ULNRC-4051
TAC No. MA2312

DOCKET NUMBER 50-483
CALLAWAY PLANT
REQUEST FOR RELIEF FROM ASME CODE

RELIEF REQUEST ISI-16

FIG. IWB-2500-11 PIPE BRANCH CONNECTION

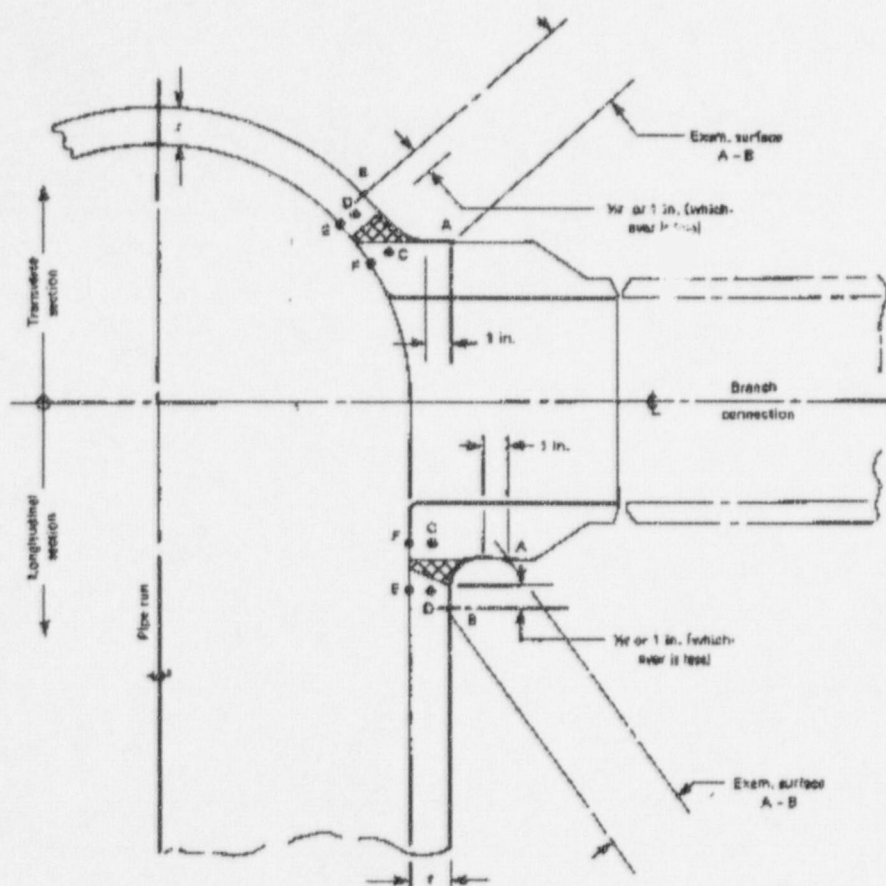
3. In the July 10, 1998 submittal, the conclusion is made that the ASME Code requirement is impractical to perform. The information provided in Relief Request ISI-16 does not adequately support the reduced composite examination coverage of 23%. Please provide information, with sketches if necessary, describing the limitations associated with this examination.

The RHR suction line is connected to the RCS using the configuration shown on Attachment 1. The RHR piping nozzle is 6" NPS and the RCS Piping is 29" inside diameter. The RCS piping material is Centrifugally Cast Stainless Steel (SA-351 CF8A). ASME Section XI figure IWB-2500-11 Pipe branch connection (Attachment 1) shows two views (in one drawing) of the weld configuration.
